U.S. Application No. 09/415,060

Docket No. 0378-0360P

AMENDMENTS TO THE DRAWINGS

Fig. 4

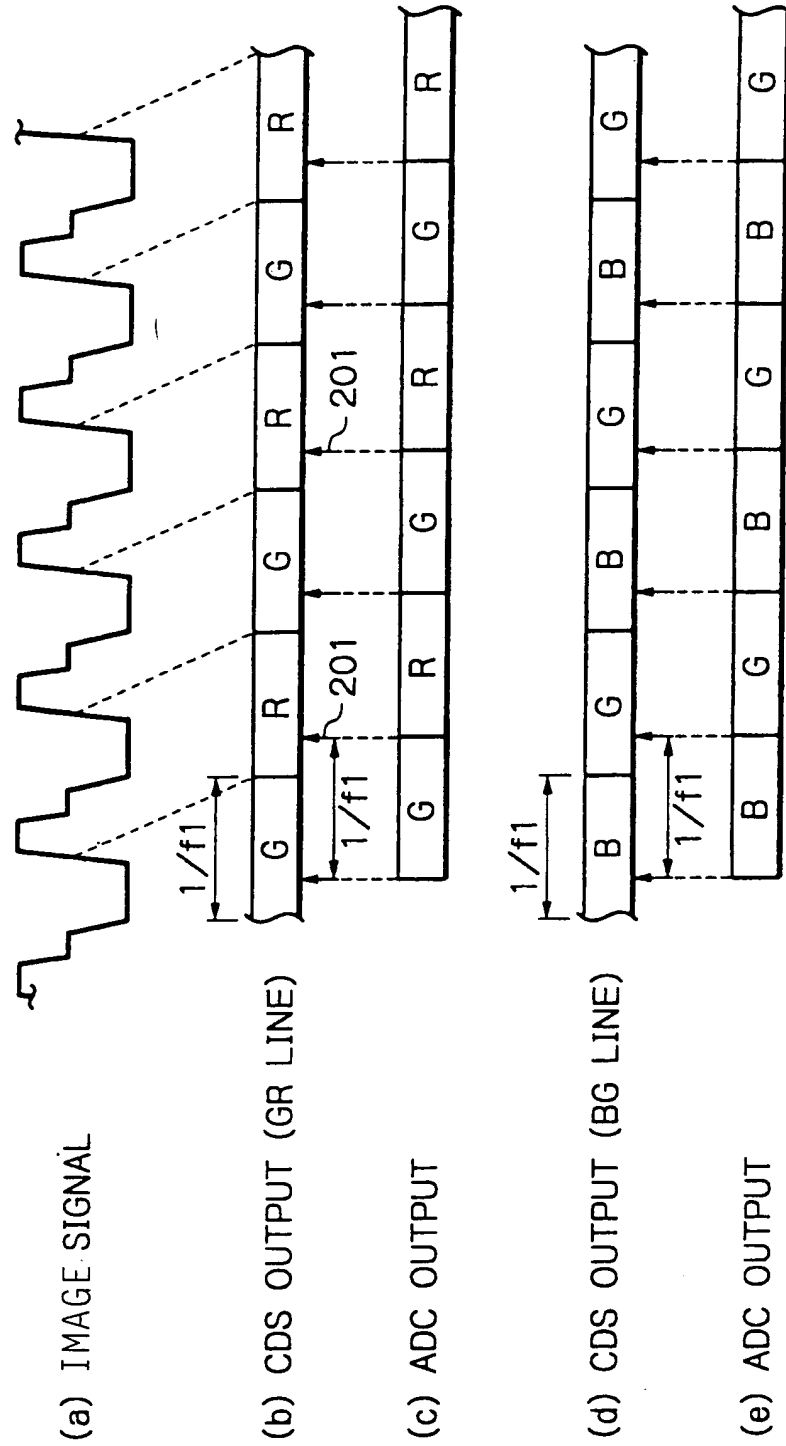
- In Figures 4 and 5, the word "IMEGE" has been corrected to "IMAGE". No new matter is believed to be added by this amendment.
